Delegated Report

Application No:	20240654
Location:	Bowling Green, Church Walk, Gravesend DA12 2QU
Description:	Application for a non-material amendment to planning permission reference number 20221328 to allow the relocation of substation within the site, aligning projections, changes to balconies and changes to window depths / proportions.
Applicant:	Mr Barbara, McCarthy Stone

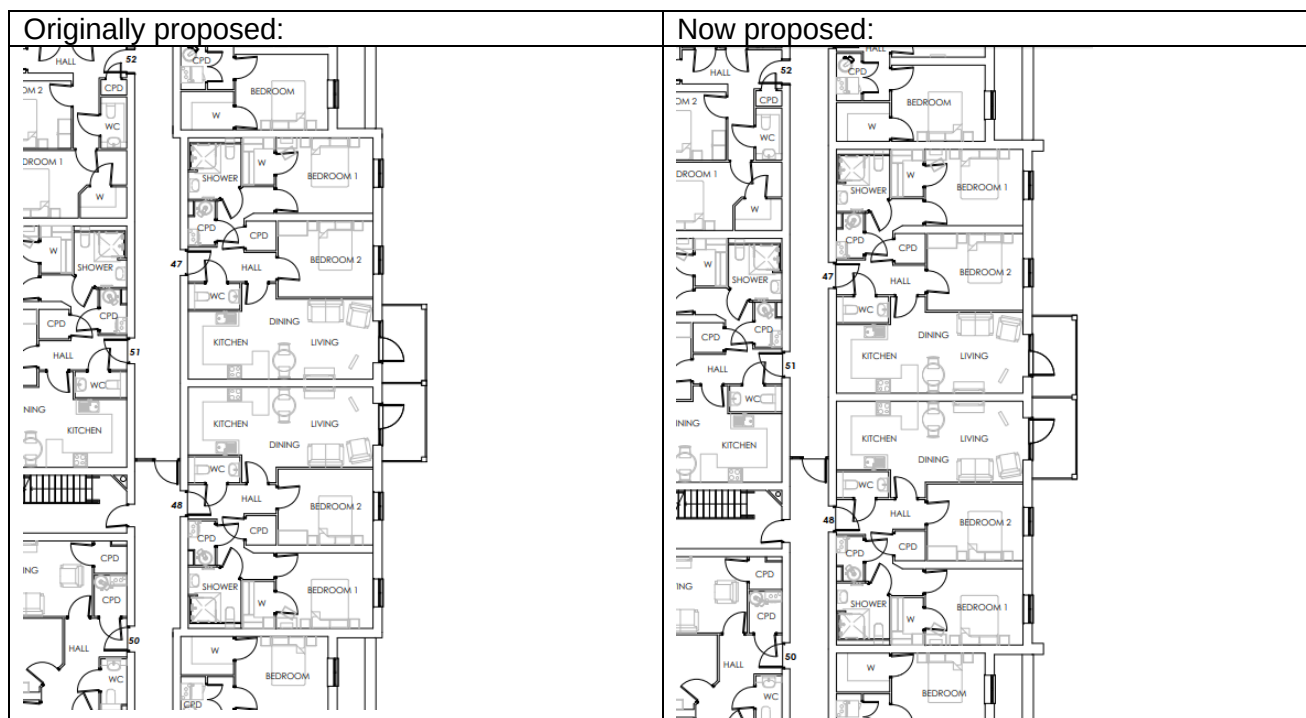
1. *Substation repositioned to south-eastern corner of site, now accessed from Church Walk.*

The substation was proposed adjacent to the parking at the entrance but this is now to be relocated to the south-eastern corner of the site fronting Church Walk. This is a less conspicuous location surrounded by soft landscaping. This change improves the appearance of the site and is not considered material.

2. *Projecting units in central portion of eastern elevation to Church Walk aligned/projection removed, replaced with brick details*

The middle units of the eastern side of the building were shown to project slightly forward of the side elevation by approx. 30mm. These are now shown to sit flush with the rest of the side elevation. The plan below shows the originally proposed second floor and the now proposed second floor:

As can be seen above this change results in some additional brick detailing to each side of this section of the building. The loss of the set forward does not change the appearance significantly on its own and can be considered non-material. (It is not clear why there is a taller roof behind the building in the proposed drawing as this does not appear to relate to any of the other drawings and is assumed to be an error).

3. *Balcony surrounds removed, replaced by simple balcony posts (across all elevations)*

The loss of the balcony surrounds can also be seen in the drawings above. The below drawing shows the originally proposed northern elevation:

The below drawing shows what is now proposed:

The balcony surrounds added architectural interest to the building. The loss of these will result in a bland appearance that results in a monotonous building in a prominent location. The changes to the design are not considered an improvement and are significant enough to warrant consultation particularly given the proximity of a listed building. This change is not considered non-material.
